RECREATIONAL VEHICLE SERVICE CAMPAIGN

SERVICE ADVISORY 25-466

SERVICE ADVISORY # 25-466

A/C Wiring Arcadia, Avalanche

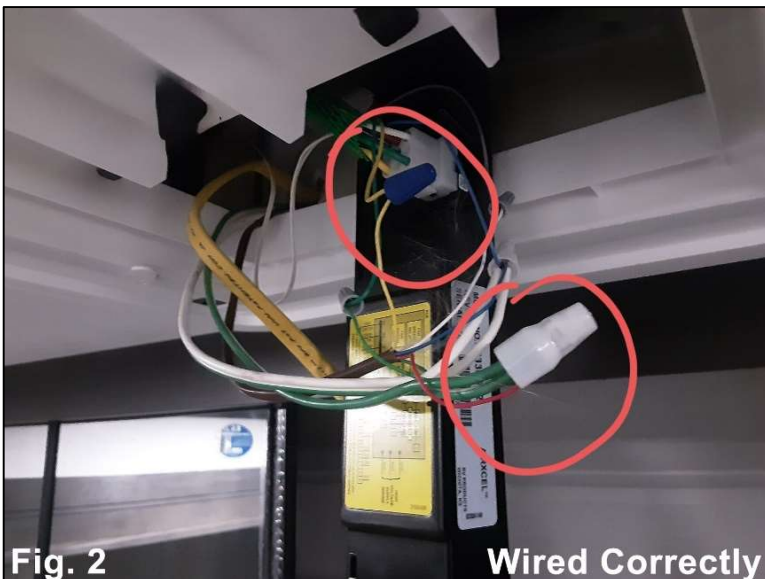
The remedy is to correct the AC thermostat wiring. The yellow wire connected to the two green wires is incorrect. The yellow wire connected to the red wire is also incorrect. Correct the wiring as shown below.

At each AC unit equipped, remove the lower assembly and air filter to access the control board and wiring, as shown in Figure 1.

Access wiring and locate the two green wires with the yellow wire and disconnect those wires. Locate the yellow and red wire and remove disconnect those wires.

Bell cap the two yellow wires together and bell cap the two green wires to the red wire together, as shown in Figure 2.
